Subject: Notification of Class 2 Permit Modification Request to the Hazardous Waste Facility Permit, Number: NM4890139088-TSDF

Class 2 Permit Modification Request

Addition of a Shielded Container

**Waste Isolation Pilot Plant
Carlsbad, New Mexico**

Figure 1
Shielded Container

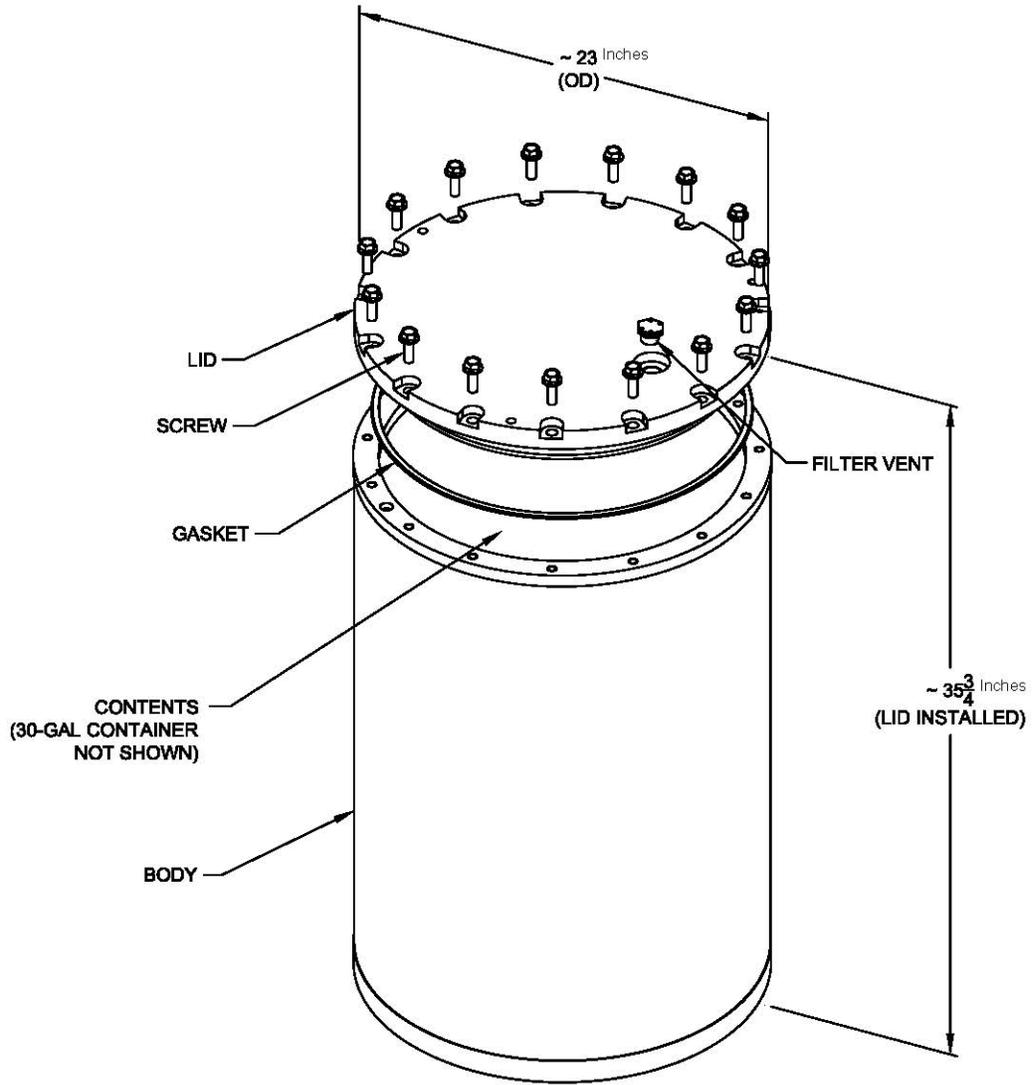
34 The Permittees are proposing to add a new payload container to the Permit which is designated
35 as a shielded container (shown in Figure 1). This container is similar in size to a standard
36 55-gallon drum. The shielded container body side wall is constructed of an approximately 3/16-
37 in. inner steel shell, an approximately 1-in. middle layer of lead, and an approximately 1/8-in.
38 outer steel shell. The shielded container lid and base are each constructed of approximately 3-
39 in. steel plate. The lid is bolted on. A gasket of silicone rubber is utilized for lid closure. The
40 empty weight of the shielded container is approximately 1,726 pounds. The shielded container
41 accommodates a 30-gallon steel drum which will contain RH TRU mixed waste. Both the
42 shielded container and its 30-gallon steel drum are vented in accordance with transportation
43 requirements. The shielded container vent port includes a lead shield plug. Although the 30-

Figure 2
Three-Pack Assembly of Shielded Containers with Axial and Radial Dunnage

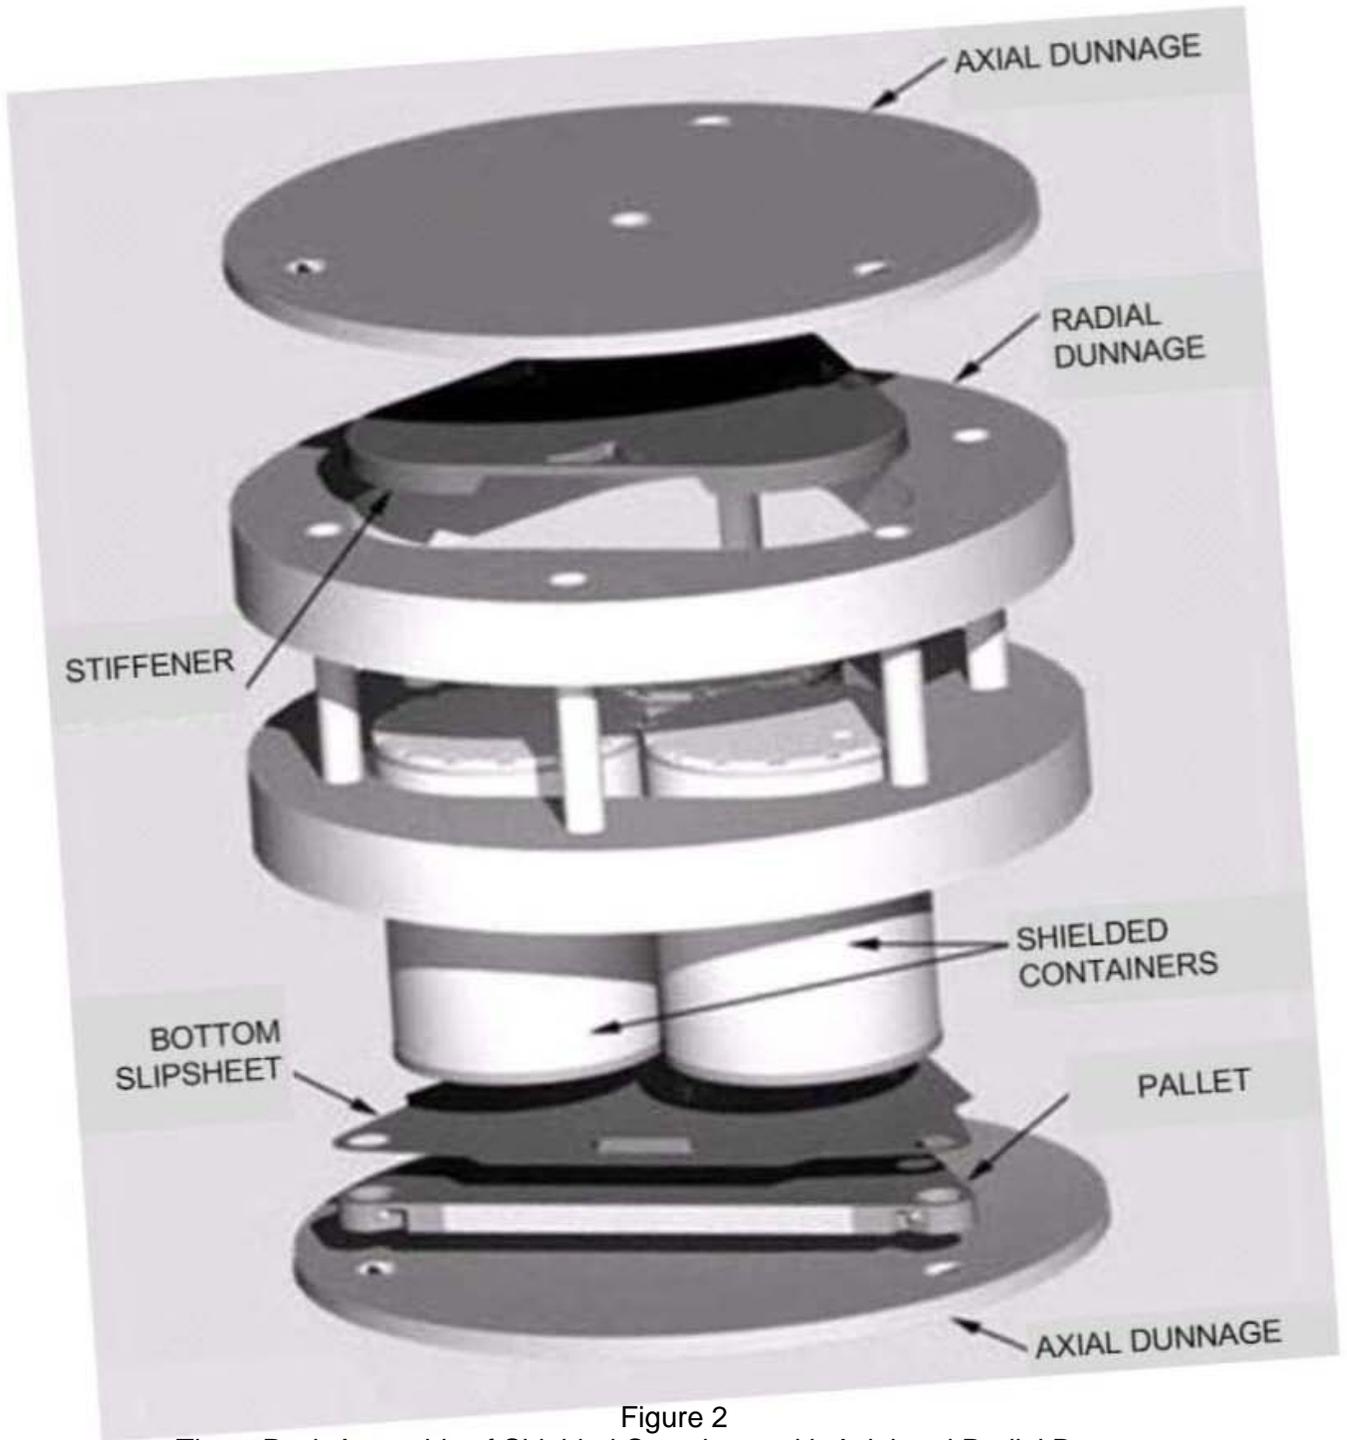
8
9 The shielded containers will be assembled for shipment from the generator site in a three-pack
10 configuration on a triangular pallet surrounded by radial and axial dunnage components. These
11 components are designed to keep the load from shifting during transportation. They will be
12 transported as a single three-pack configuration within the HalfPACT packaging. Currently, RH
13 TRU mixed waste is transported in RH 72-B packaging. The shielded containers will be
14 transported in HalfPACTs with no more than three HalfPACTs per shipment. Not all RH TRU
15 mixed waste will be packaged in shielded containers. Therefore, both RH 72-B and HalfPACTs
16 will be shipped to the WIPP facility. Using shielded containers has the potential to reduce the
17 number of shipments so, therefore, there is no additional risk. Furthermore, regardless of the
18 number of shipments, the Permittees are not requesting an increase in the storage capacity of

Figure A1-37
Typical Shielded Container

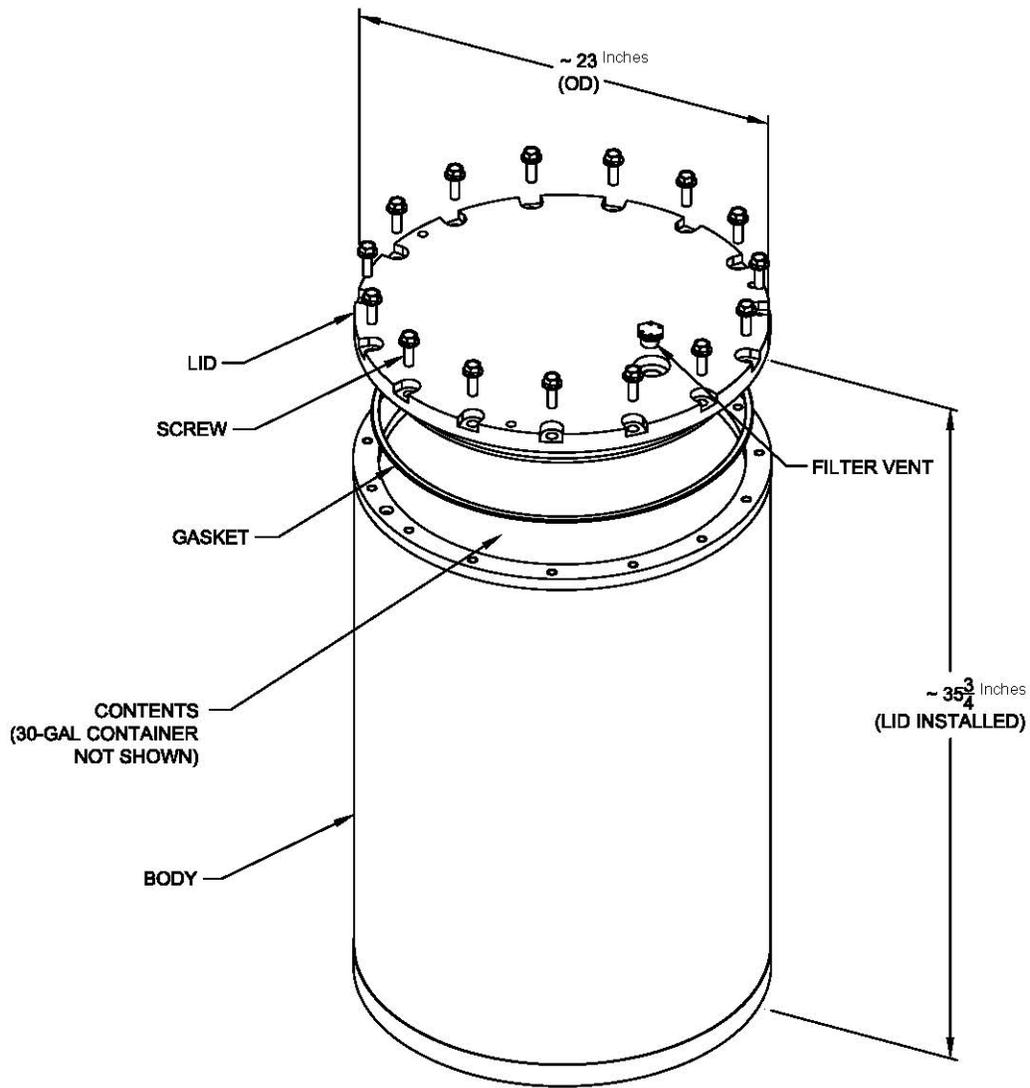
- 14
- 15 3. Add a figure of the shielded container (Permit Attachment A1, Figure A1-
16 37).
- 17
- 18 4. Add "Shielded Containers" to Permit Attachment C1, Sections C1-1a and
19 C1-1a (1) and revise Permit Attachment C1, Table C1-8 indicating that
20 the 55-gallon drum DAC bounds the shielded container.

9
10 Remote-Handled TRU mixed waste received at the WIPP facility in shielded containers will be
11 arranged as three-packs. A summary description of the shielded container is provided below.
12 The shielded container meets the requirements for DOT specification 7A (Figure A1-37).
